Rotor and Rotor Base for MSD Crank Trigger Distributors with the Large Cap PN 8457

Figure 1 Updated and Discontinued Rotors and Bases.

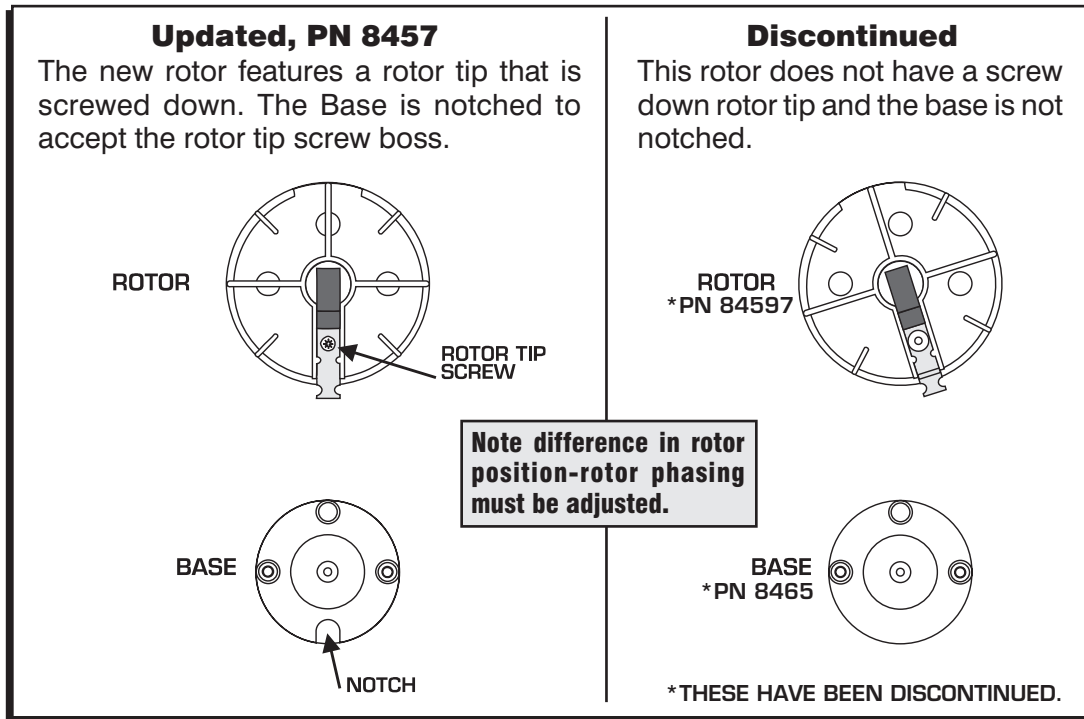
This Rotor and Base have been updated and **will not interchange** with the older style rotor or base. To differentiate between the two, see Figure 1. The PN 8457 Rotor and base replaces rotor, PN 84597, and base, PN 8465.

Note: The position of the new rotor on the base has also changed which means that the rotor phasing **must** be reset.
